2_11 EXPRESSWAY GUTTER AND CONCRETE BARRIER

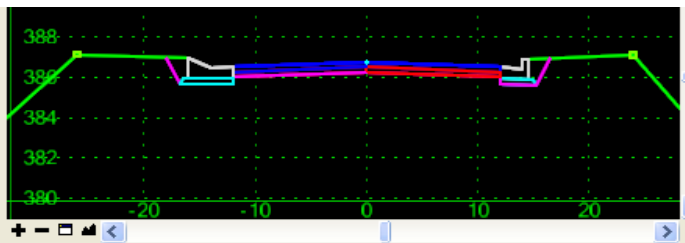
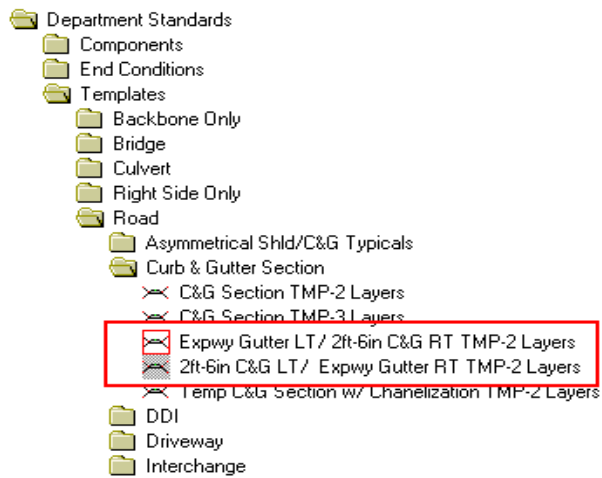
1. Can a template be created to have an expressway gutter on the left and a 2'-6" curb and gutter on the right?
2. Division 14 has a shoulder typical section on the left and an expressway gutter with a concrete barrier on the right. Can this template be created in the standard library?
